BEFORE THE UNITED STATES
ENVIRONMENTAL PROTECTION AGENCY

IN THE MATTER OF THE PROPOSED)
LISTING OF RICHARDSON FLAT)
TAILINGS, SUMMIT COUNTY, UTAH,)
ON THE NATIONAL PRIORITIES LIST)
)
) COMMENTS OF UNITED PARK
) CITY MINES COMPANY IN
) OPPOSITION TO PROPOSED
) RULE

E&E 1985 Sample Sites

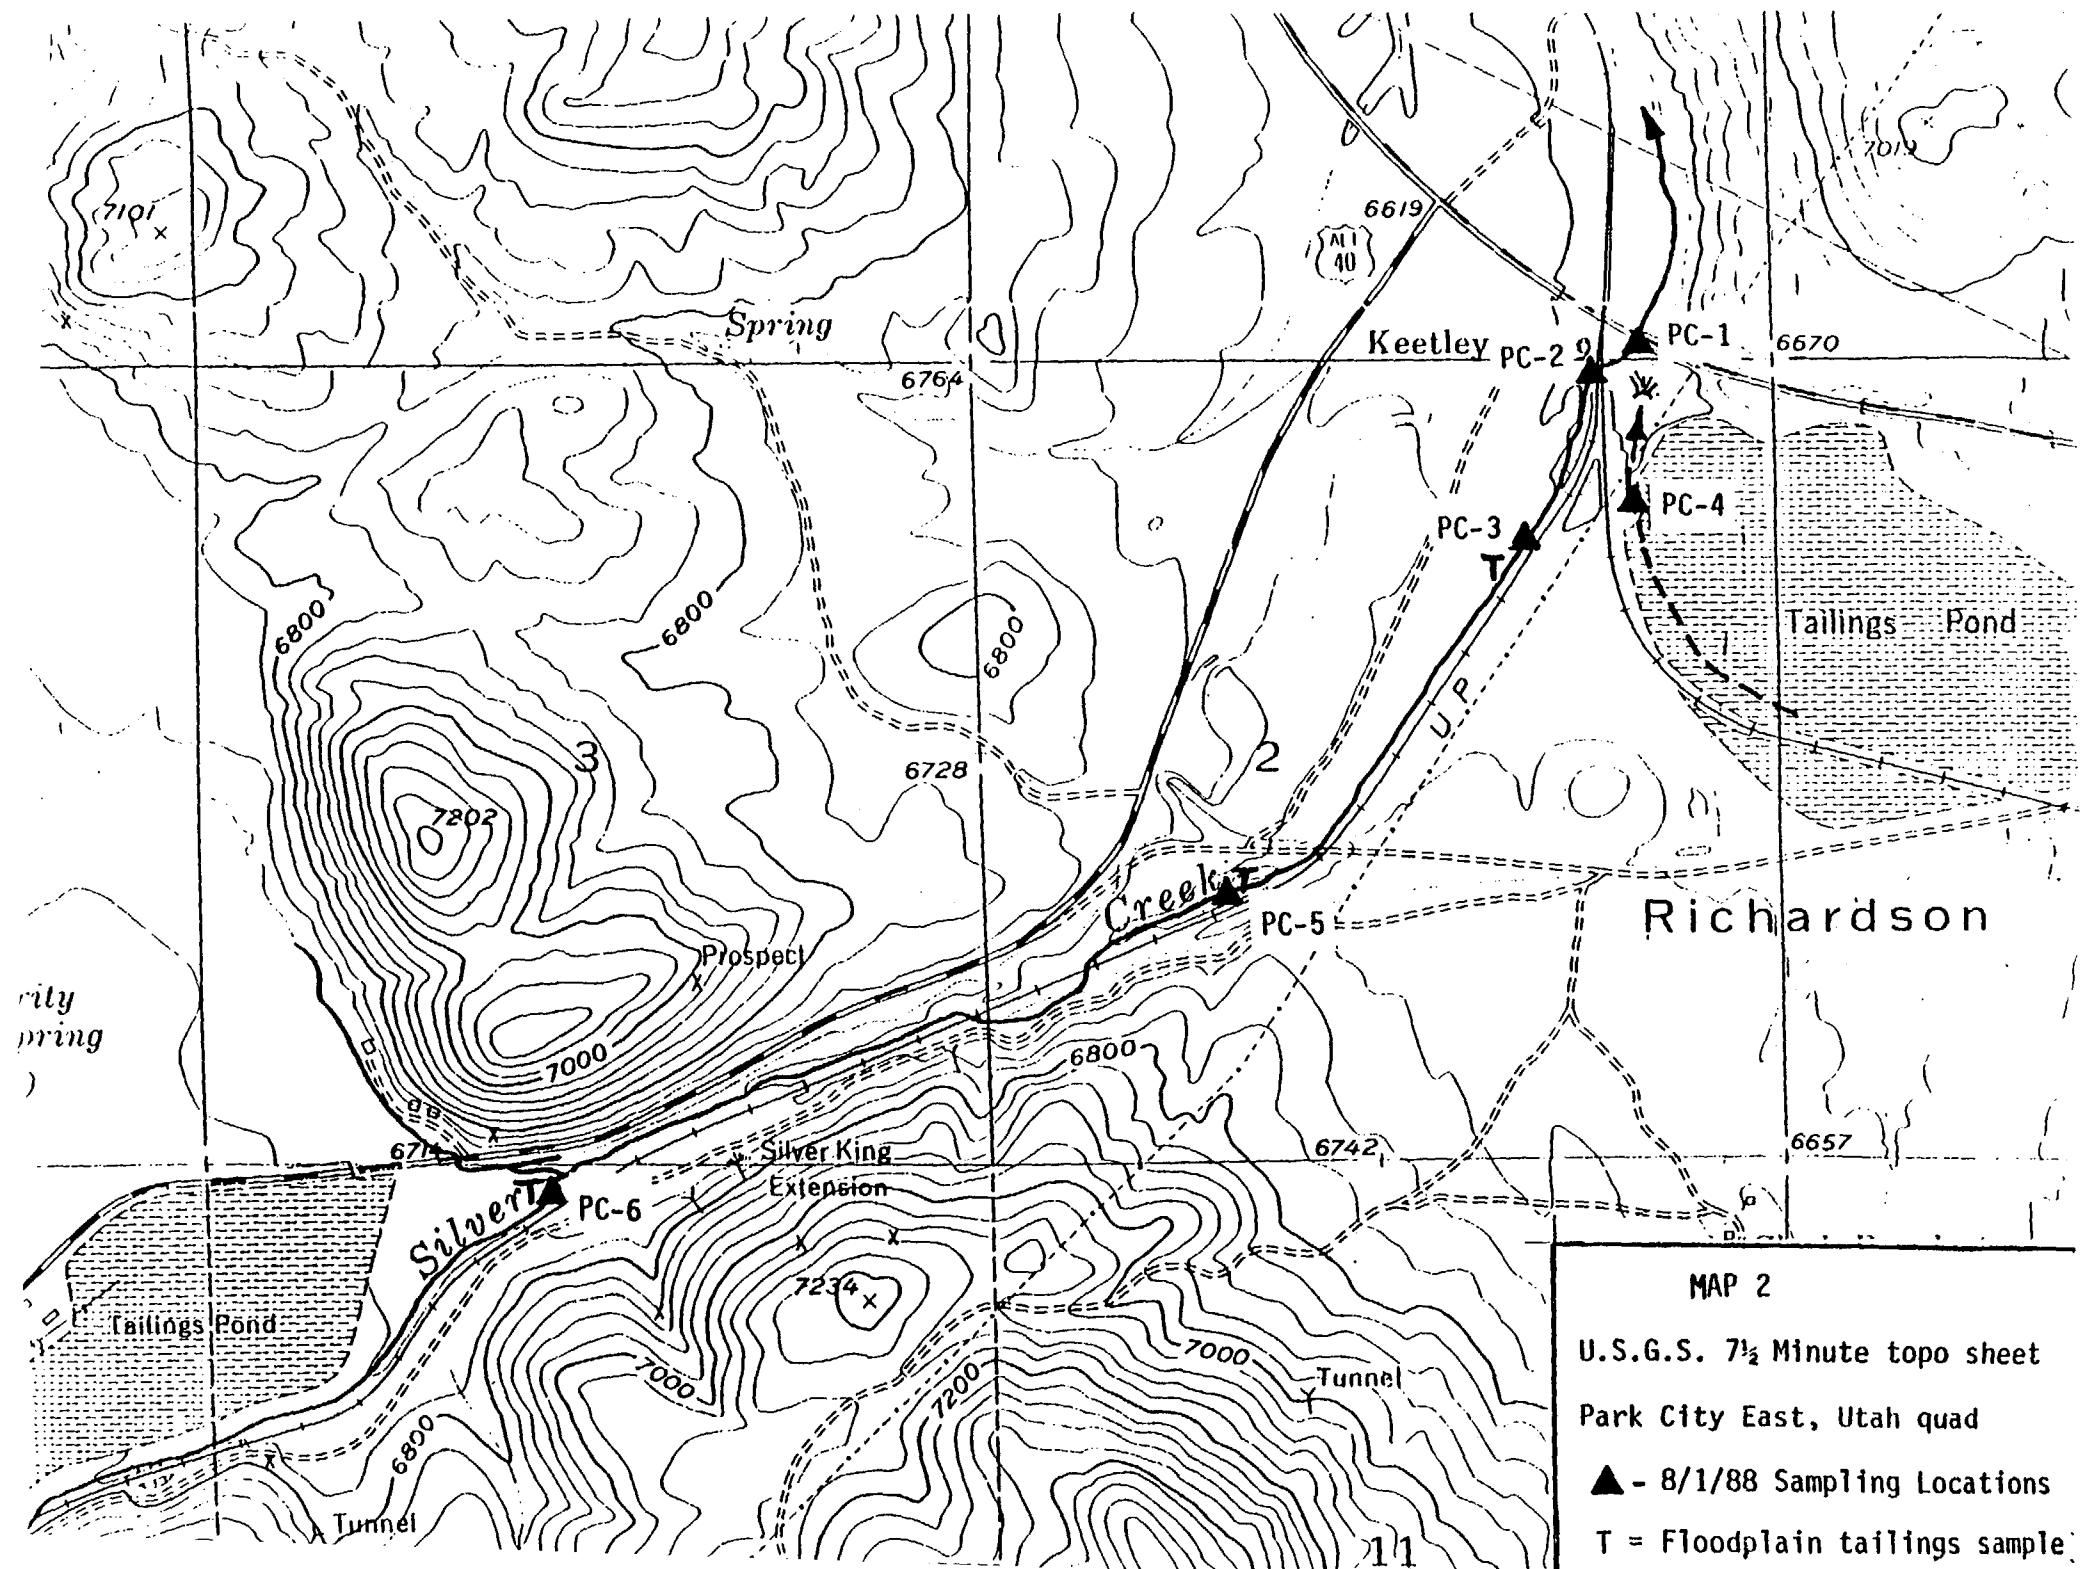
The score for Observed Release for the Surface Water Route should be 0 because no release is demonstrated by the data collected during June 1985 by EPA's contractor E&E. The sample listed as downgradient (RT-SW-3) was collected at the railroad

trestle at Keetley Junction, as per Figure 2 of both the Analytical Results Report and the Report of Sampling Activities, telephone communication of August 8, 1985 between Ms. Sue Kennedy of E&E and Kerry Gee, United Park, and as described on the Chain of Custody Record (attached hereto as Exhibit "A") given to United Park for its splits of samples received on June 20, 1985. This location is, in fact, upgradient from any hydrologic influence of the Richardson Flat tailings (see Map 1 attached hereto). The map (Figure 2) provided in E&E's Report of Sampling Activities and Analytic Results is grossly in error and Map 1, attached hereto, illustrates the correct hydrologic and spatial relationships in question.

Exhibit "B"). The sample site at the railroad trestle, which E&E characterizes as the "downgradient" sample site, is United Park's upgradient NPDES sampling location. As shown on Map 1, the railroad grade forms a barrier between the Richardson Flat tailings and Silver Creek. Any influences from the diversion ditch or any seepage from the tailings dam would be restricted by the railroad grade and prevented from intermingling with Silver Creek. As shown on Map 1, any influence from Richardson Flat tailings would have to enter Silver Creek through the marsh between the railroad trestle (E&E's RT-SW-3 sampling location) and the culvert under US-40 (United Park's downgradient sample location). Therefore, the correct sampling locations to measure possible releases from Richardson Flat correspond to those regularly sampled by United Park pursuant to its NPDES requirements; that is: the upstream sample at the railroad trestle and the downstream sample at the culvert under US-40. These locations have been regularly sampled since 1977 under the NPDES permit and the NPDES data have been analyzed and are summarized below:

MAP 2

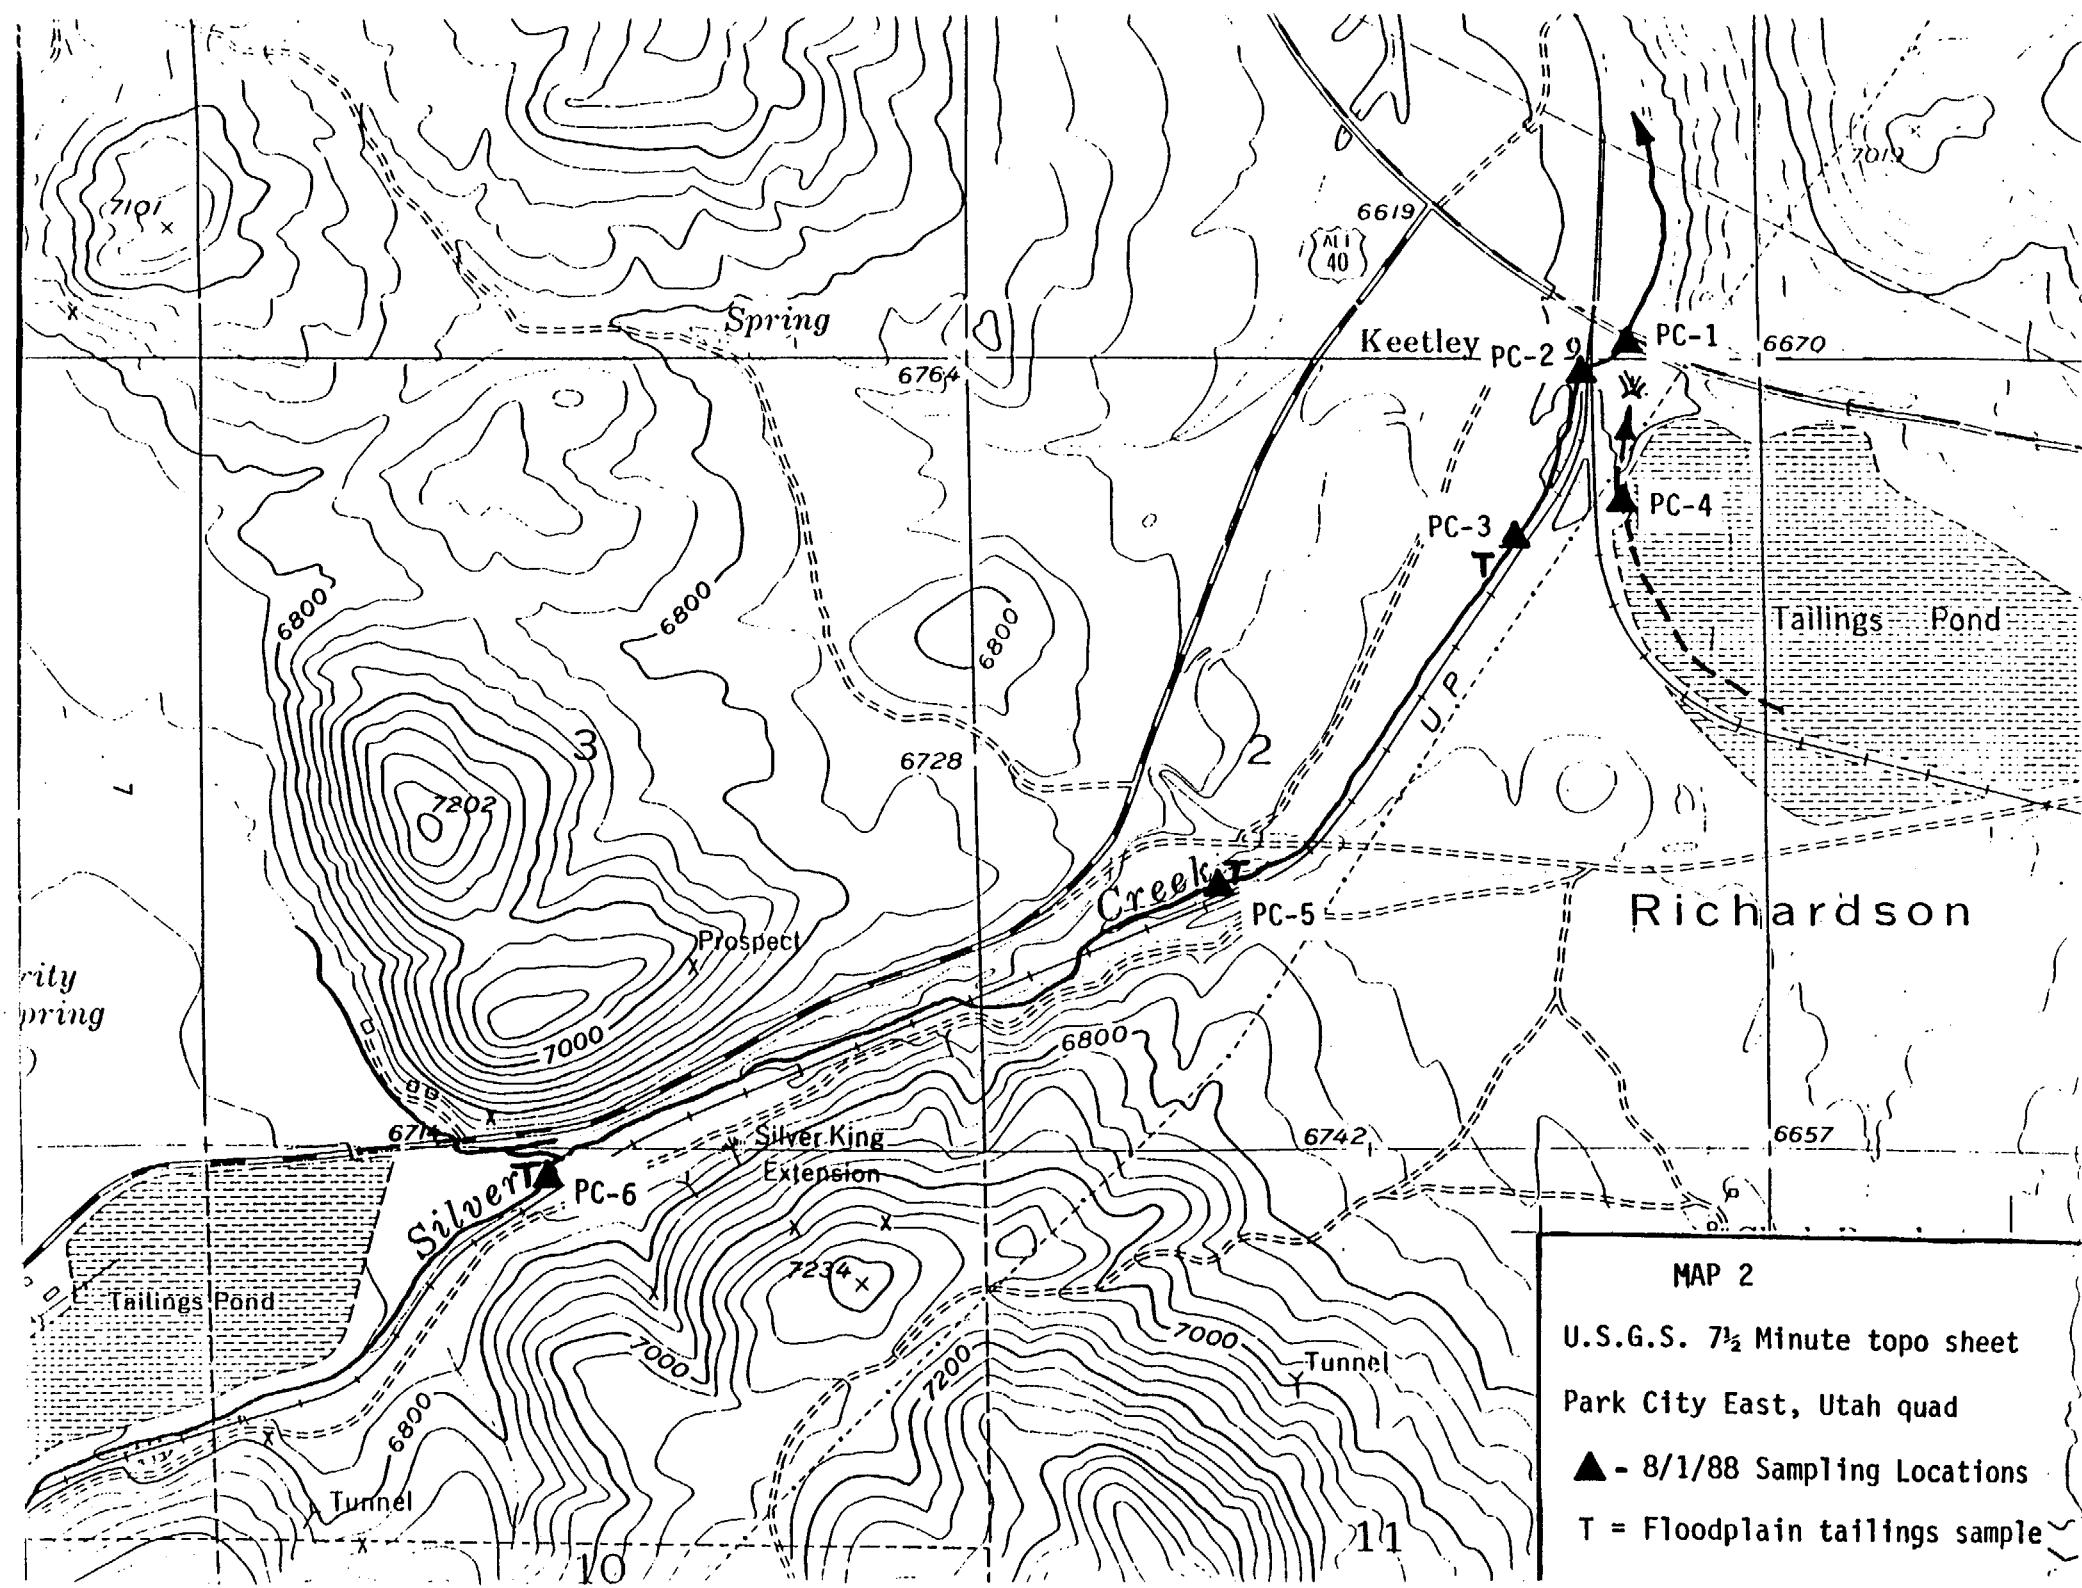
The difference found between RT-SW-1 and RT-SW-3 in E&E's 1985 sampling is most likely due to entrainment of particulate material from the banks and bedload of Silver Creek. A review of aerial photos, a ground check, and several samples (Map 2) confirm the floodplain downstream from Prospector Square is covered with stream deposited tailings.

Consequently, the suspended load within Silver Creek can contain these tailings and associated metals. Total metals analyses reflect these suspended tailings in the stream water and show a great deal of variance depending on sampling methodology, sampling locations, and seasonal variables (spring runoff, storms, dry periods, irrigation withdrawals, etc.). These factors can easily account for the high metal concentrations found in RT-SW-3 by E&E in 1985. Filtered water samples are specific to dissolved metals and eliminate the influence of suspended particulate material. These samples provide a more accurate measure of metal content in the water available for uptake by plants, humans, and livestock. Table 2 compares total and dissolved metal concentrations found in Silver Creek on August 1, 1988 (locations correspond to those on Map 2).
